# HISTORIC AND DESIGN REVIEW COMMISSION

**HDRC CASE NO:** 2013-283  
**ADDRESS:** 408 E. Houston  
**LEGAL DESCRIPTION:** NCB 416 BLK 23 LOT 22 (SAT HOUSTON SUBD)  
**ZONING:** D H HS RIO-3  
**CITY COUNCIL DIST.:** 1  
**DISTRICT:** Alamo Plaza Historic District  
**LANDMARK:** Yes - Alterman's and United Cigar Building  
**APPLICANT:** Nick Naik  
**OWNER:** SA Hou Alamo LLC  
**TYPE OF WORK:** Revisions to previously-approved scope  
**REQUEST:**

The applicant is requesting a Certificate of Appropriateness for approval of the following revisions to the hotel design at 408 E Houston:

FIRST FLOOR PLAN  
SHEET  
**A1.01**

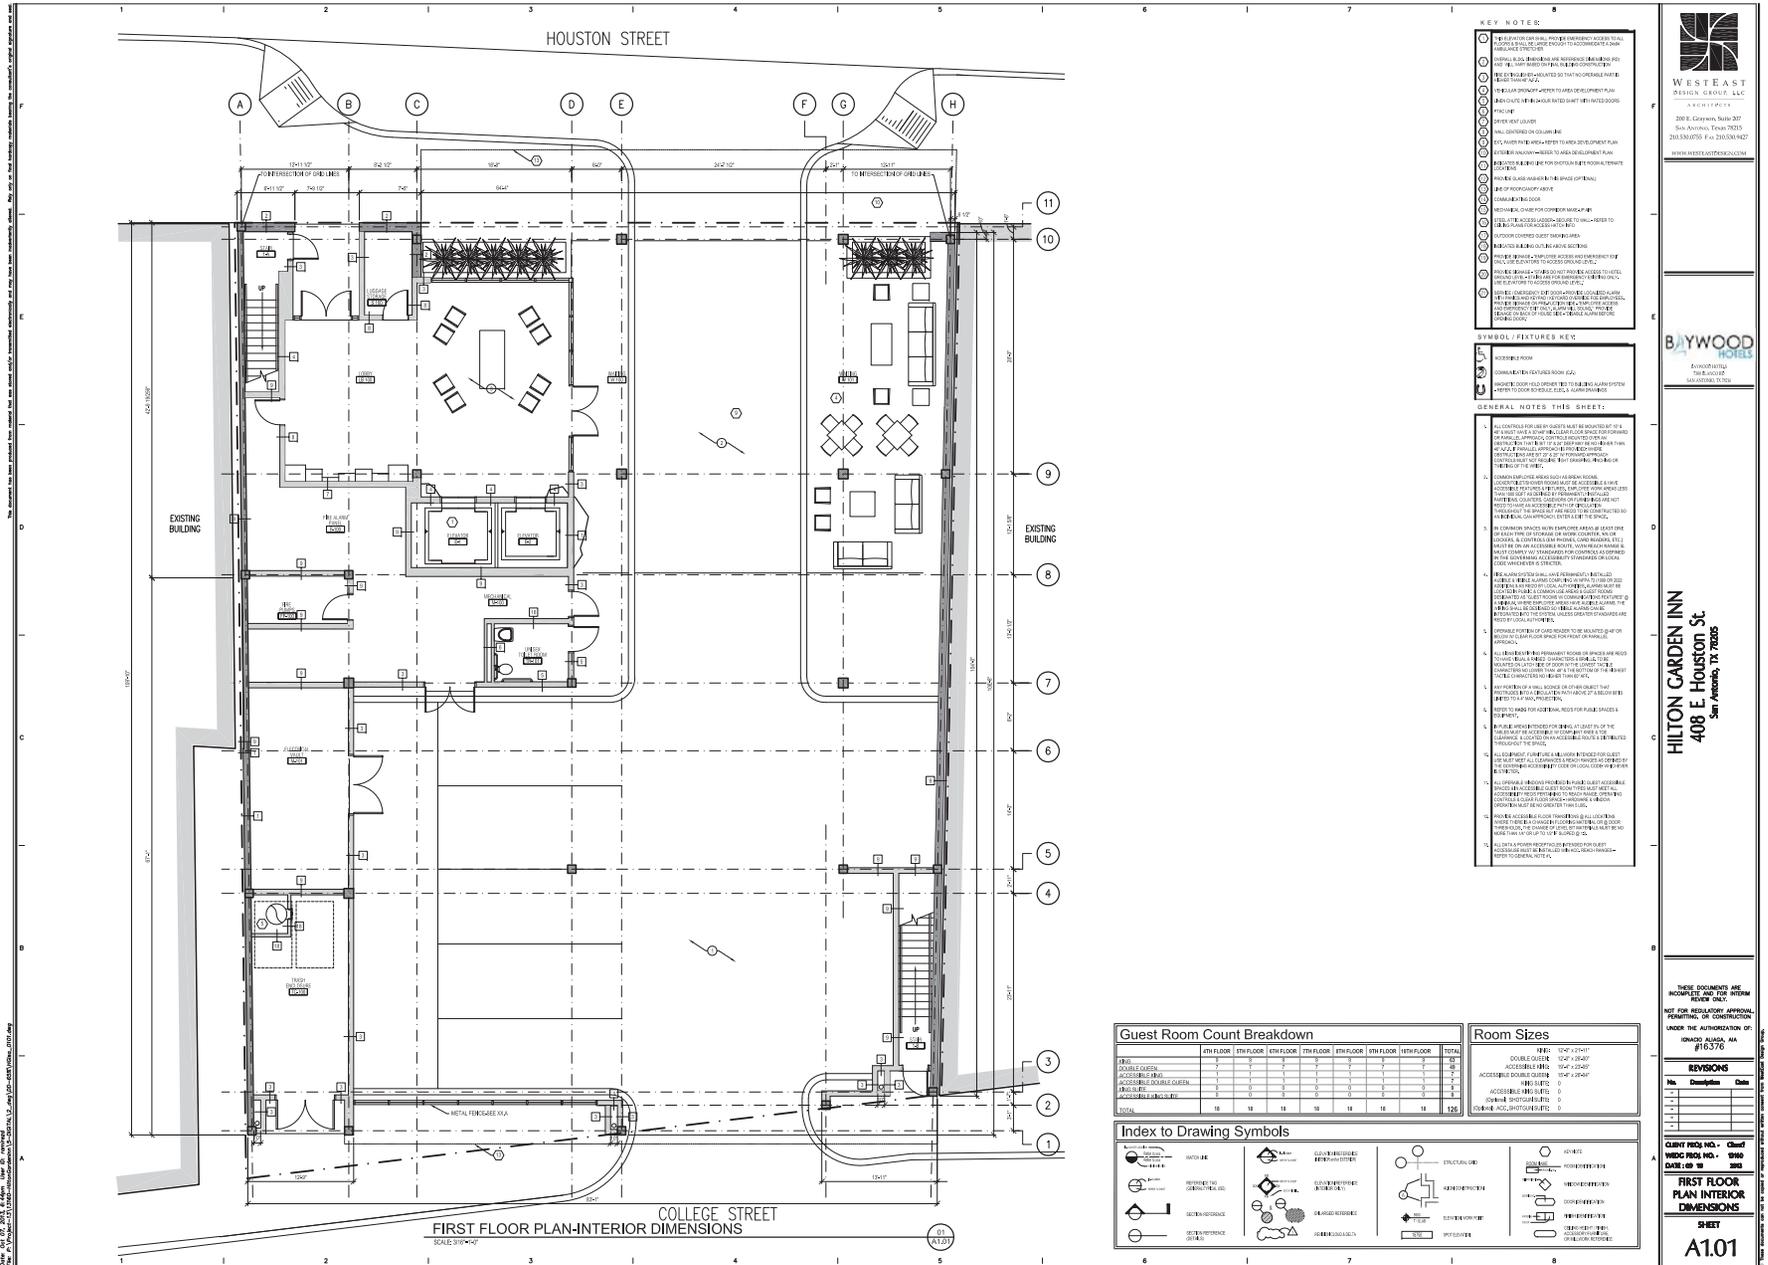
- a. A Certificate of Appropriateness for the construction of the hotel was approved on October 15, 2013, with the stipulation that the vehicular entry off of Houston Street be reduced to a single lane. The current proposal meets this requirement. Other revisions have been made to the design and have been submitted to HDRC review.

01 **TERRACE PLAN**  
SCALE: 3/16" = 1'-0"

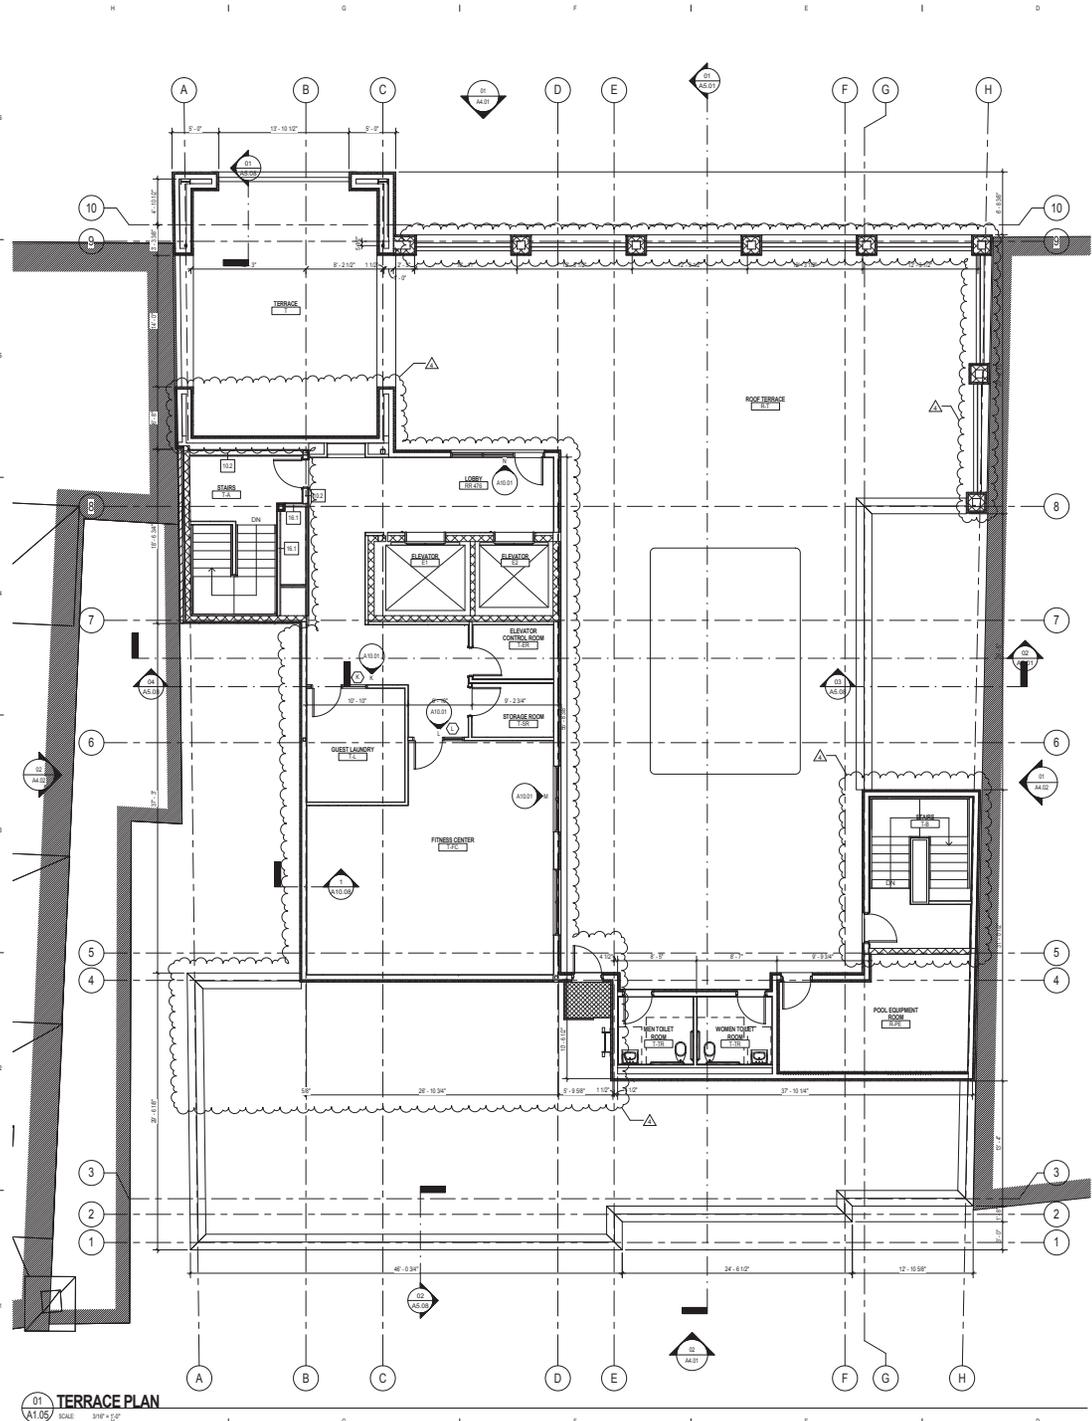
- e. The proposed changes to the rooftop terrace design also has minimal impact to the approved design and continues to provide an articulated “cap” consistent with the Guidelines for New Construction 1.C.ii.
- f. The changes to the fenestrations maintain traditional window alignment patterns consistent with the Guidelines for New Construction 1.C.i.

1-4. Staff recommends approval as submitted based on findings b through f.
